Access Compliance Report

Public Rights-of-Way

Intersection ID: 3633	Main Street: COTA_CT	Cross Street: TREYMORE_LN	Location: W
ADA ID: 006FB7B468B4	Ramp Type: Perp	Initial Pass/Fail: Pass	Overall Compliance: No
		Severity Score: 10

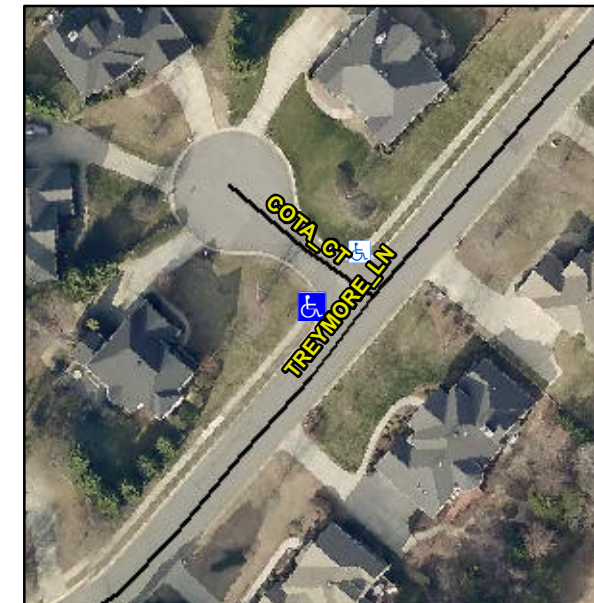
Not Found, R304.2.1, R304.2.2-Perp, R304.3.2-Para, R304.5.3, R305

Compliance	Description	Data	Compliance	Description	Data
N/A	Ramp Length (in)	43.0	Yes	Ramp Slope (%)	7.6
Yes	Ramp Width (in)	48.0	Yes	Ramp XSlope (%)	1.2
N/A	Flare Type LT	Sloped	N/A	Flare Type RT	N/A
N/A	Flare Slope LT (%)	0.9	N/A	Flare Slope RT (%)	3.4
N/A	Flare Traversable LT?	No	N/A	Flare Traversable RT?	No
No	Landing Length (in)	45.0	No	DWS Provided?	No
Yes	Landing Width (in)	81.0	N/A	DWS Contrast?	No
No	Landing Slope (%)	8.1	N/A	DWS Length (in)	N/A
No	Landing X Slope (%)	2.4	N/A	DWS Full Width?	No
N/A	Landing Curb? (Y/N)	No	N/A	DWS Offset (in)	N/A
N/A	Shared Landing?	No			
Yes	Gutter Ponding?	No	Yes	Gutter Slope (%)	0.9
Yes	Gutter Lip Ht (in)	0.0	Yes	Gutter X Slope (%)	1.0
N/A	Painted X Walk1?	No	N/A	Painted X Walk2?	N/A
	X Walk 1 Direction	To NE		X Walk 2 Direction	N/A
N/A	X Walk 1 Width (in)	N/A	N/A	X Walk 2 Width (in)	N/A
	X Walk 1 Slope (%)	4.0		X Walk 2 Slope (%)	N/A
	X Walk 1 X Slope (%)	2.5		X Walk 2 X Slope (%)	N/A

Remove & Replace Entire Ramp.
